Technical Service Bulletin

MODEL(S) T300/T300e Models

SUBJECT: Scrub head lift pedal difficult to disengage from raised position.

PURPOSE: To improve scrub head lift pedal function, order Pedal Latch Upgrade Kit p/n 9014788.

Old style pedal latch

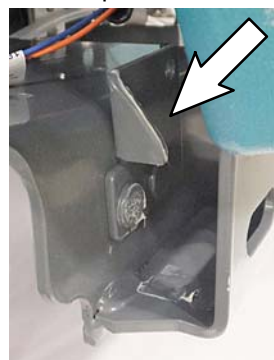
The Pedal Latch Upgrade Kit includes the necessary parts to rework all model types (Disk, Orbital and Cylindrical).

New kit pedal latch

New kit slide roller assembly
(Disk/Orbital models)

New kit slide roller assembly
(Cylindrical models)
